Direct circuit monitor Model Number List(12-inch)

Direct circuit monitor Model Number List(10-inch & 7-inch)

Direct circuit monitor wiring (10 inch & 7 inch)

DM-10WC

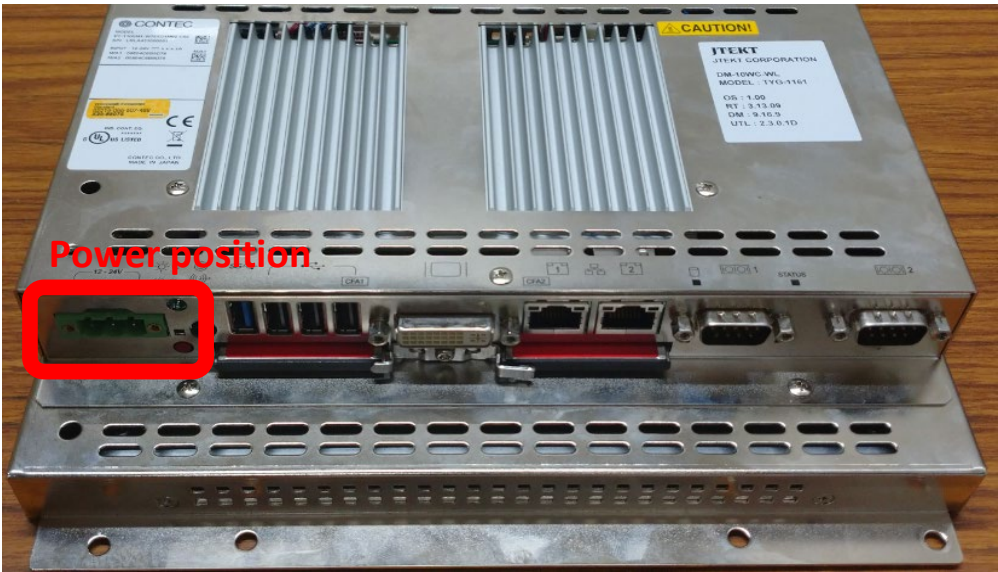
The number of pins on the power connector has been changed from 2 pins to 3 pins.

DM-7WC

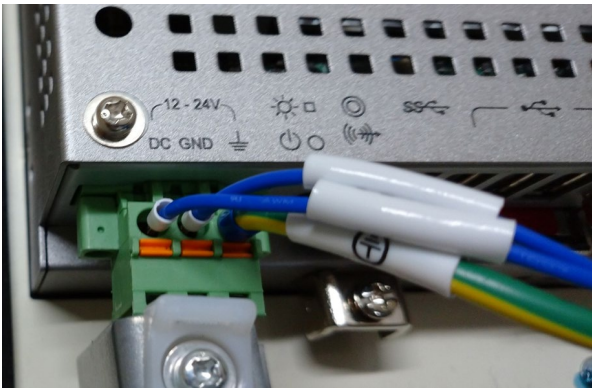
The number of pins on the power connector has been changed from 2 pins to 3 pins.
In addition, DM-7WC has a screw to fix the connector to the main body.
When replacing, fix the connector to the main body and attach it to the operation panel before wiring.
